PROPOSED DEVELOPMENT, FRASER DRIVE - SOUTH TWEED

Ecological Buffer Analysis

PROPOSED DEVELOPMENT, FRASER DRIVE - SOUTH TWEED ECOLOGICAL BUFFER ANALYSIS

FIGURE 4

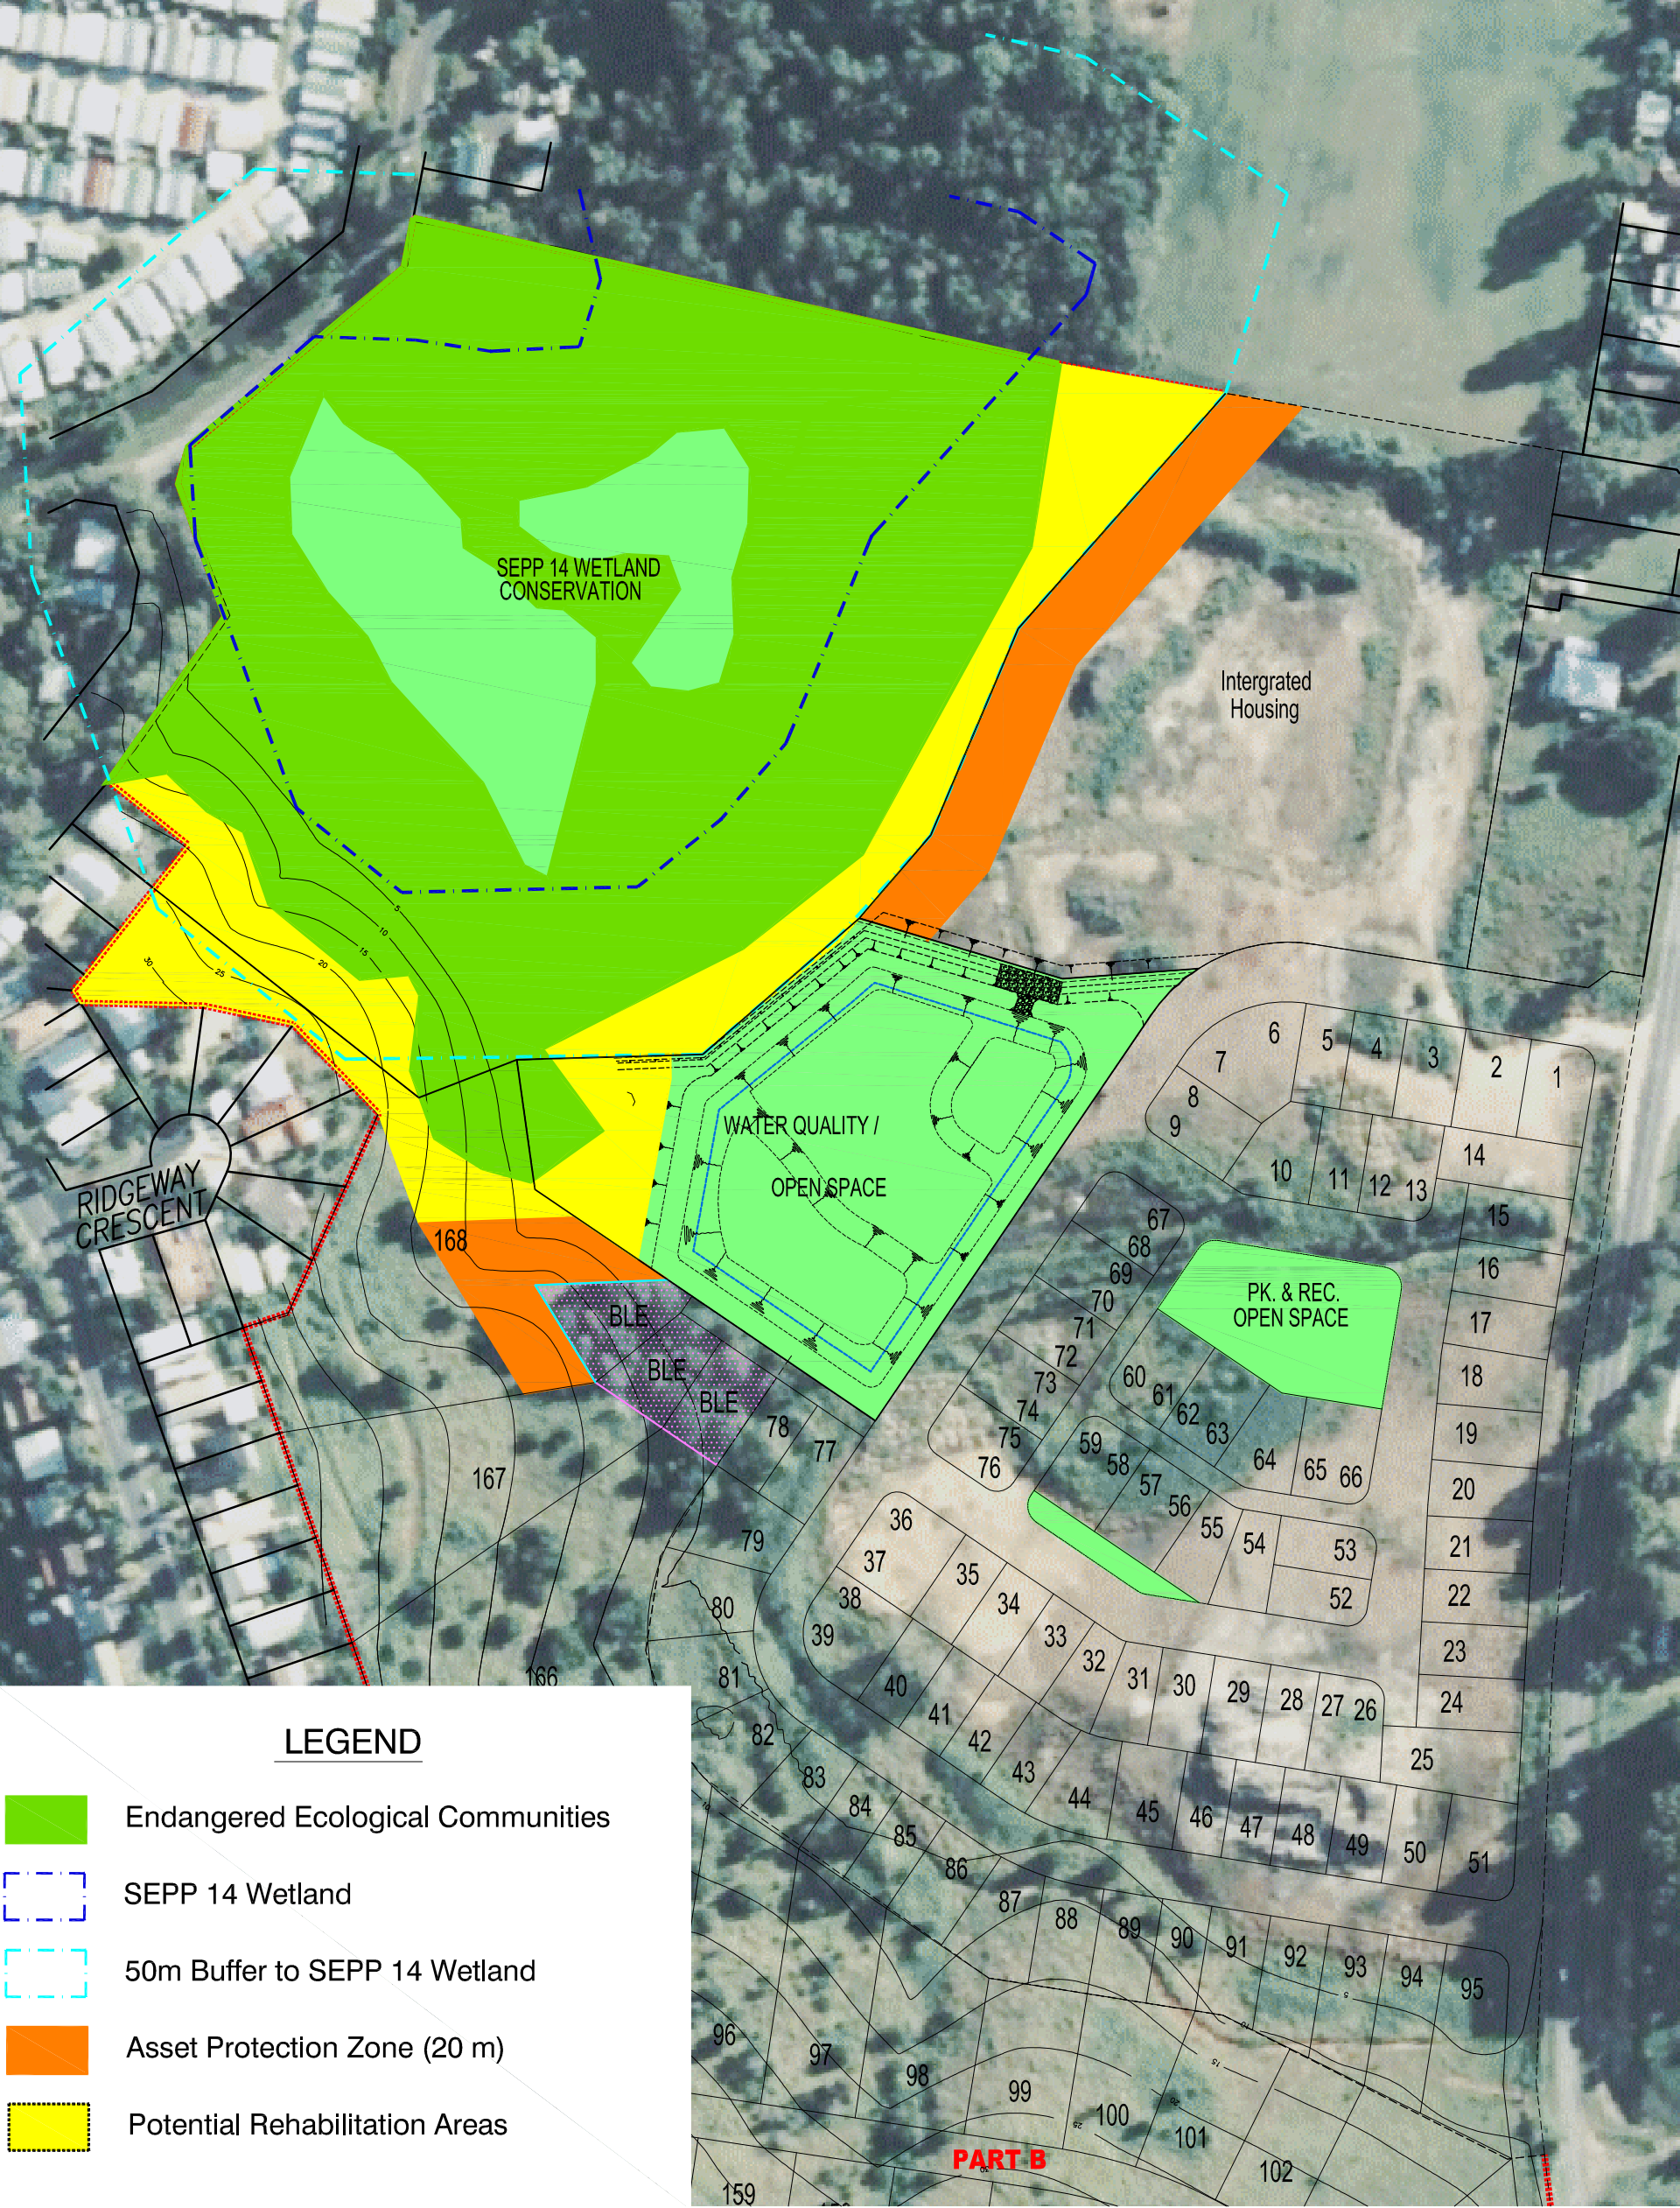
The *Ecological Buffer Analysis* does not provide adequate justification for a reduced buffer between the EECs and the integrated housing allotment. The report fails to adequately address the key question of why a reduced vegetated buffer width (as small as 10 metres) should be considered acceptable in this instance. Key pieces of policy and legislation relevant to the issue have not been addressed and incorrect buffer distances have been quoted in the report. Furthermore, a proposed buffer structure has not been provided.

- Section 4.1 states that *“on-site buffers that are required as part of the proposed plan of development need to encompass the SEPP14 wetland area and the proposed EECs that extend outside of the SEPP14 wetland area”*. The ecological buffer should be sited adjacent to the wetland and EECs to protect these ecologically sensitive lands and should not include these areas.

- The report states that *“The transfer of management of land that contains the SEPP 14 wetland and EECs to Council provides an opportunity for the implementation of a bushfire management regime that takes into account the ecological requirements of the different ecosystem types that are contained within this reserve and on adjacent land to the north.”* The bushfire management regime is dictated by fuel loads specified in *Planning for Bushfire Protection (2006)* for an Asset Protection Zone, not by the ecological requirements of the ecosystem types. This is why it is critical for the APZ to be outside the ecological buffer.

- Provide a 20m APZ outside of the ecological buffer between the EECs and the proposed integrated housing allotment – the APZ may include perimeter roads and cleared road verges, or otherwise should be contained in private ownership (e.g. community title body corporate) to ensure ongoing appropriate maintenance;
